Common Structural Rules for Bulk Carriers and Oil Tankers

Technical Background for Rule Change Notice 1 to 01 JAN 2017 version

Figure 1: Handy

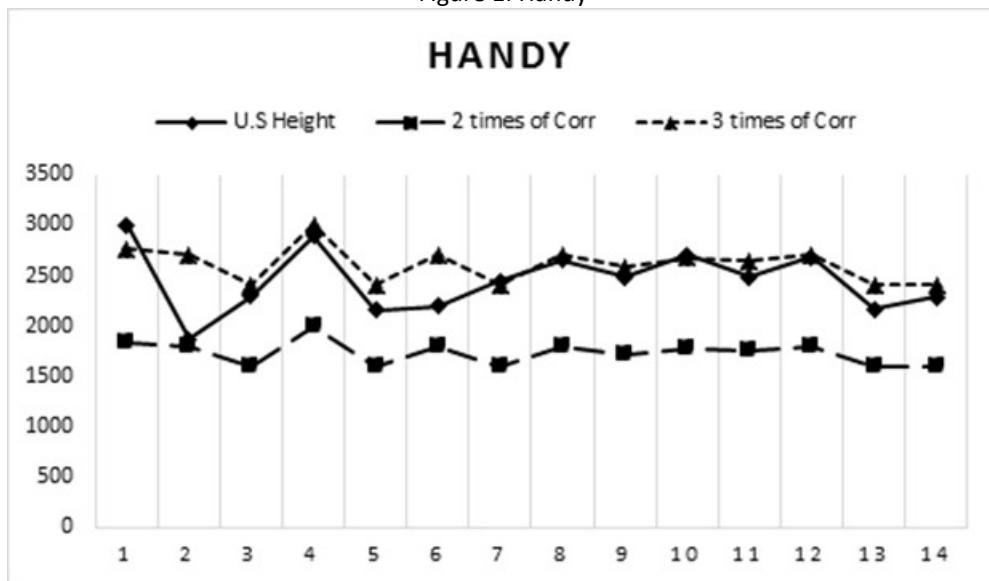
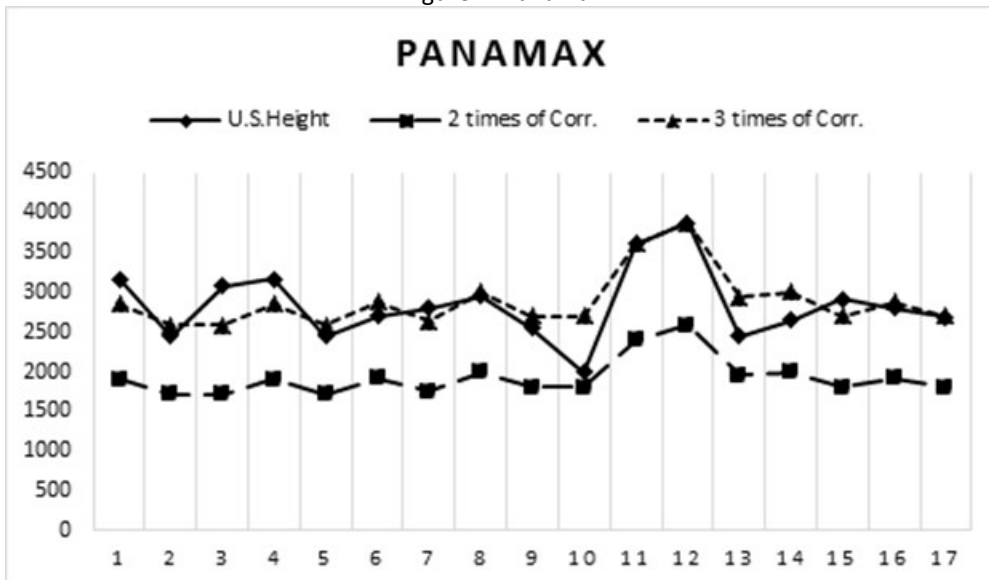
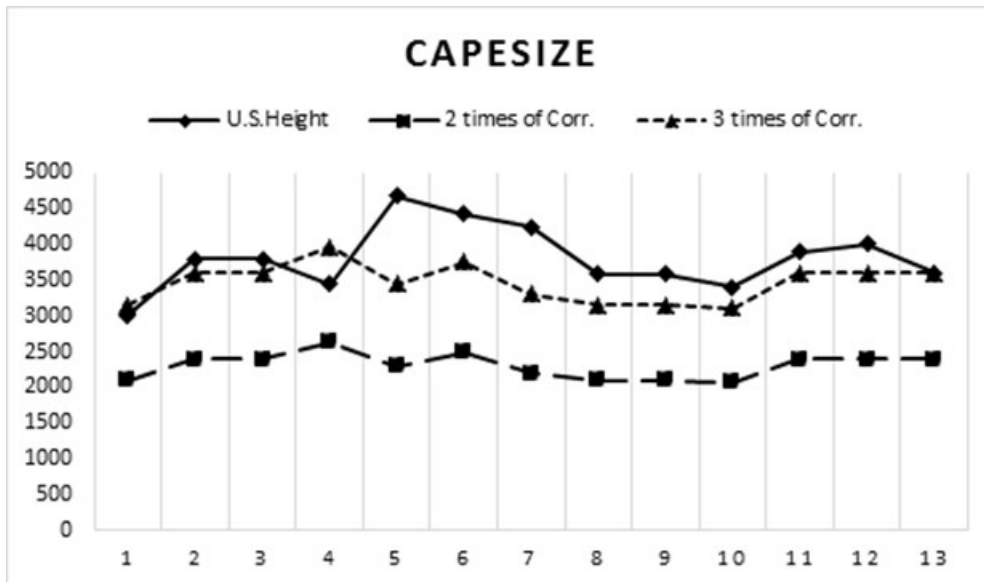
The Rule Change is to clarify the requirements of the upper stool height.

In many existing bulk carriers, the height of the upper stool is higher than three times the corrugation depth because of considerations related to a vessel's structural arrangement and not lower than twice the corrugation depth (see figures)

In addition, the Rule Change is to clarify the height of upper stool for rectangular stools.

According to the above background, this requirement is updated accordingly as prescriptive requirement for height of upper stool of bulk carriers.

Figure 1 Transom Structure Plan

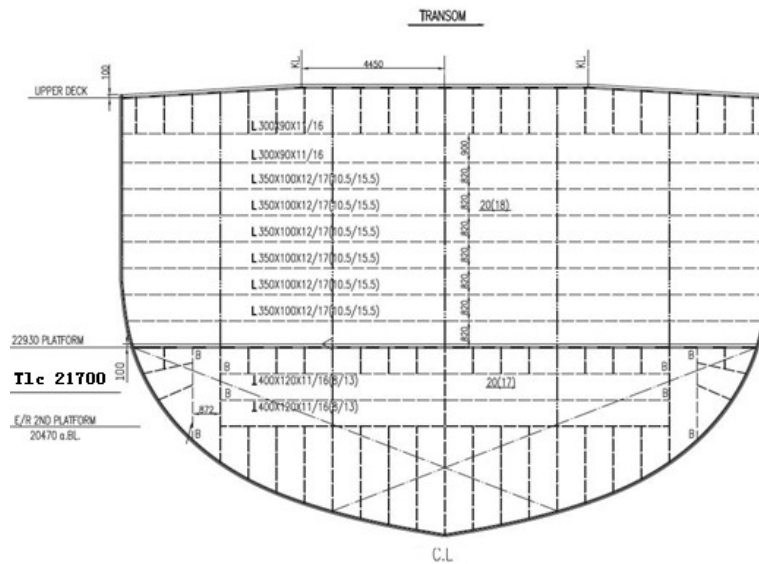
The Rule Change is to clarify the y coordinate of the load point of the transom for the external dynamic pressure to avoid misunderstanding which is applied to the structure of the transom.

In order to assess the effect of the hydrodynamic pressure, a transom structure of a VLCC is selected as in Figure 1.

Figure 2 LCPs of the model

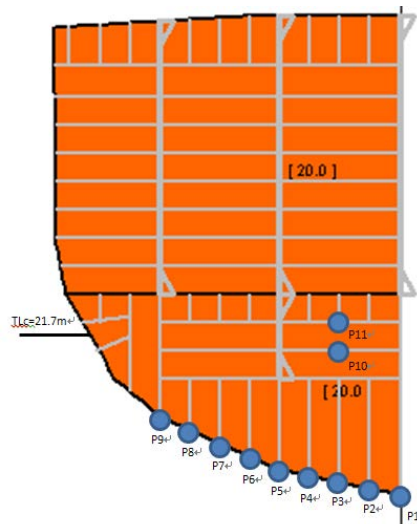
The load calculation points (LCPs) are selected as Figure 2. P1 to P9 are below the full loading draught (T_{ic}) which are on the shell, P10 is below T_{ic} which is at the middle of stiffeners, and P11 is above T_{ic} which is at the middle of stiffeners.

- a) For the LCP with $z < T_{Ic}$:
 - For P1 to P9, the hydrodynamic pressures for CSR are the same as those for RCN, because the LCPs are the same which are on the shell.
 - For P10, the hydrodynamic pressure found to be not reasonable, so RCN corrected this.
- b) For the LCP with $z > T_{Ic}$, P11, the pressure is not influenced by RCN.

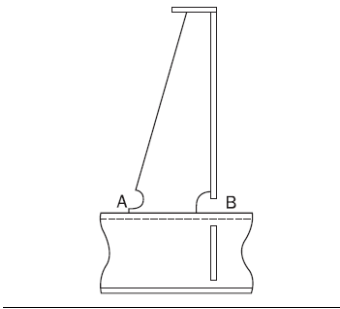
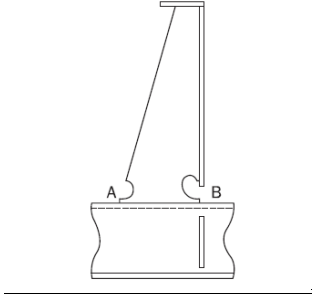
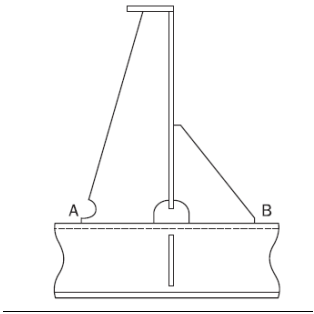
It can be seen that the hot spot stress in way of TB (ID19 & ID29) and FB (ID5 & ID26) soft toes are essentially the same.

It is concluded from this study that the assignment of higher SCF (K_a) for tripping bracket soft toes in the CSR-BC & OT Rules is unnecessary, and that assigning the same SCF (K_a) or joint class for both tripping bracket and flat bar stiffener soft toes as per the CSR-OT and CSR-BC Rules remain valid, and the CSR-BC & OT Rules should therefore be amended accordingly by adopting SCF (K_a) = 1.28 for point A of tripping bracket soft toes.

Figure 1: Fatigue Lives for Deck Connections of BC03, before and after the proposed Rule revision.

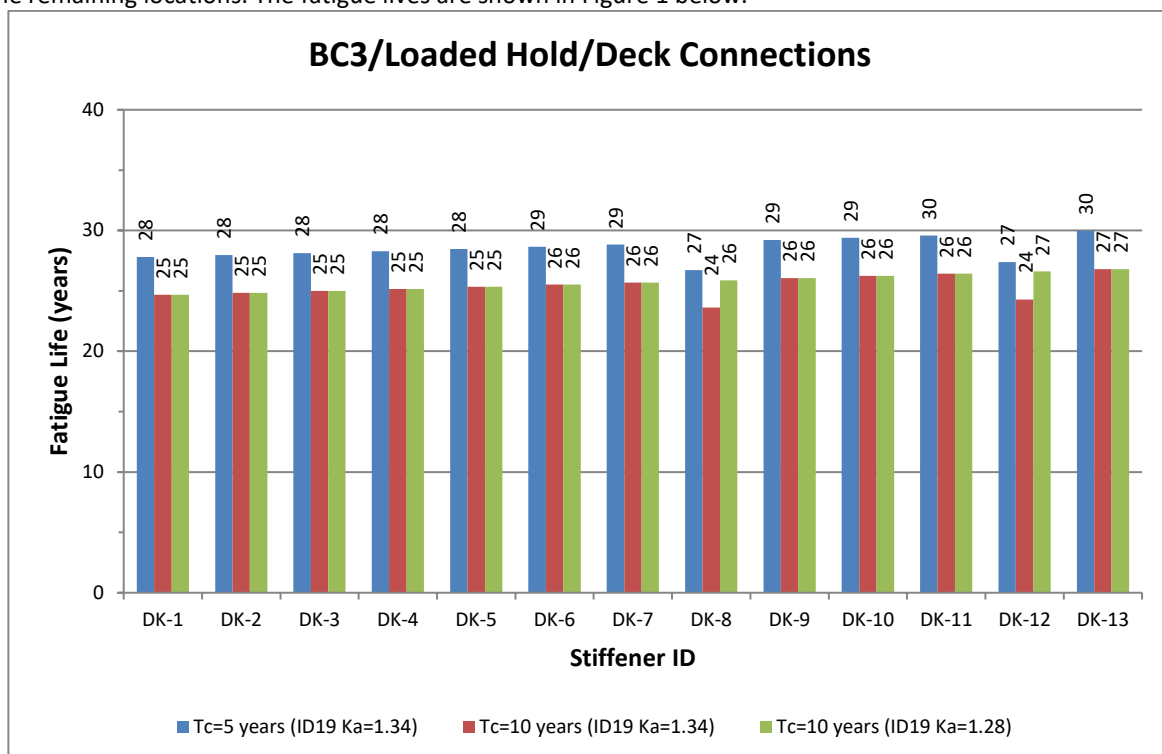
The axial stress from hull girder vertical bending is solely dominant at the deck, therefore the lowest fatigue life at a deck stiffener over the extent of the selected hold is determined at the frame locations with the highest SCF (K_a), namely tripping bracket (ID19) for DK-8 and DK-12 and web stiffeners with double soft toes (ID5) for the remaining locations. The fatigue lives are shown in Figure 1 below.

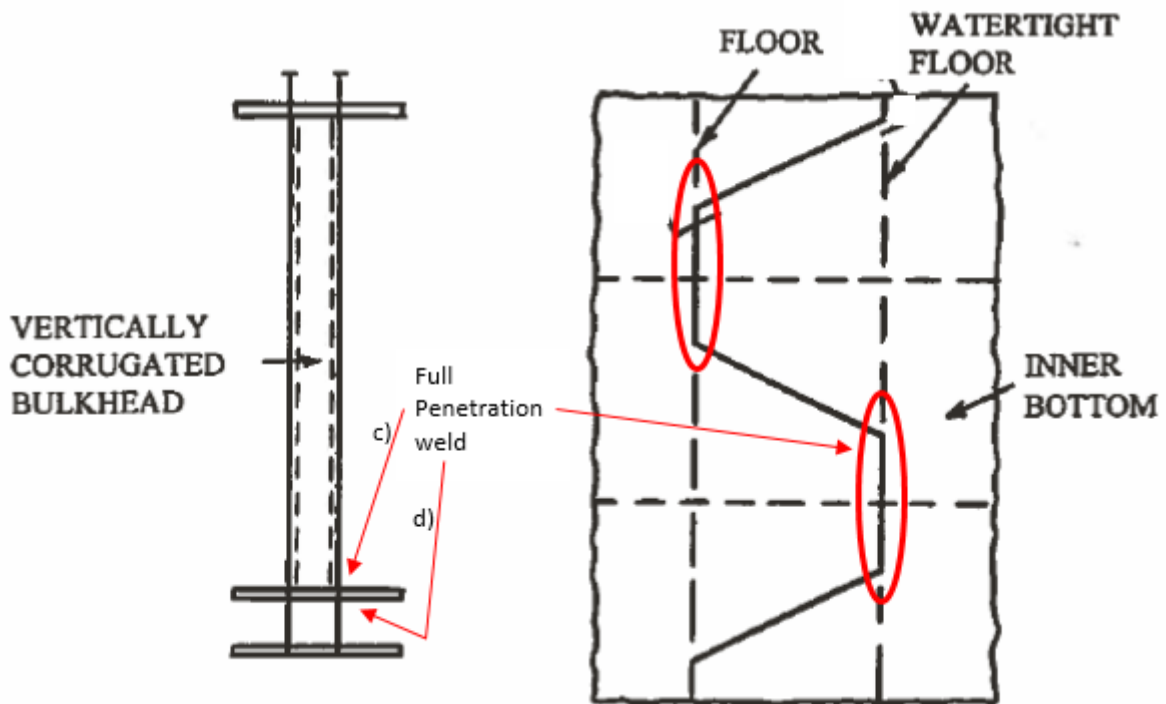
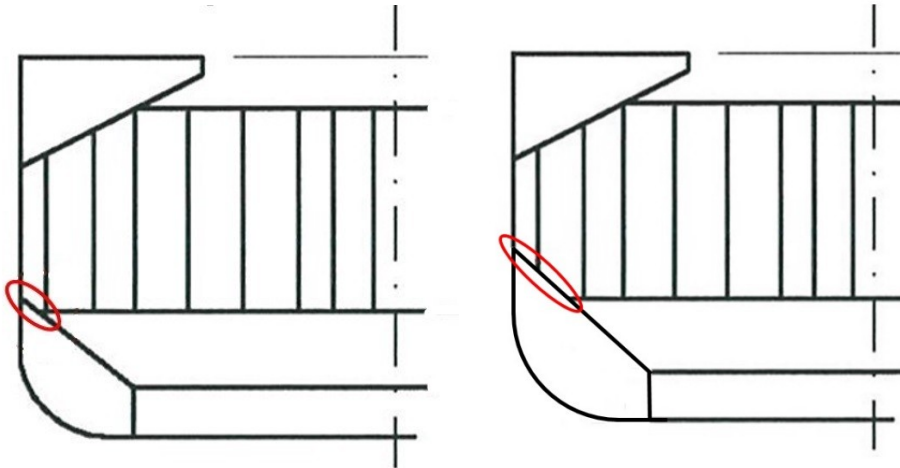
Locations where the rules require full penetration welding were added. The main reasons for this are as follows:

- a) Localized fractures have been encountered in pre-CSR vessels.
- b) Feedback from vessel operators from the IACS Knowledge Centre database shows several requests regarding the weld detail connections of corrugated bulkhead since 2013. The following sentence is a typical request extracted from the database:
“Welding requirements in the CSR-H should change. **Full penetration welding is to replace partial or deep penetration welding** for the critical areas unless advanced fracture mechanics analysis is to be undertaken.”
- c) Feedback from the IMO GBS audit team, see GBS observation IACS/2015/FR1-8/OB/07 as follows:

The technical background offers no explanation or justification as to why partial penetration welding may suffice in these critical areas that are prone to cracking.

Furthermore, the provision giving the choice to the shipbuilder between full and partial penetration welding needs to be contrasted with IACS Rec. No.76 and Rec. No.96 which presently require the much safer full penetration welding for the repair of critical areas in bulk carriers and tankers.

The proposed amendment is made because of the above feedback and experience.

Figure 1. The upper and lower connections of side frame

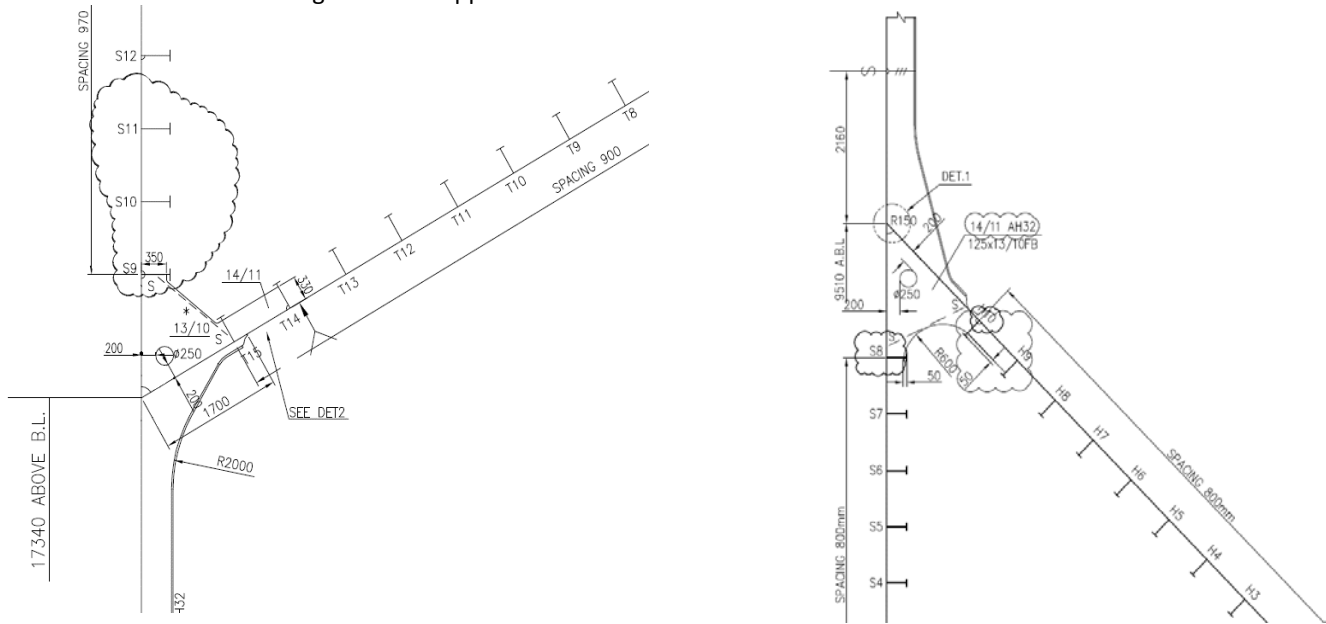
As an example, a representative Capesize bulk carrier is assessed to illustrate the consequences of the Rule Change. Cross sections of the upper and lower connections of side frame are provided as Figure 1.

According to the consequence assessment in Table 1 and Table 2, there is no impact in scantlings.
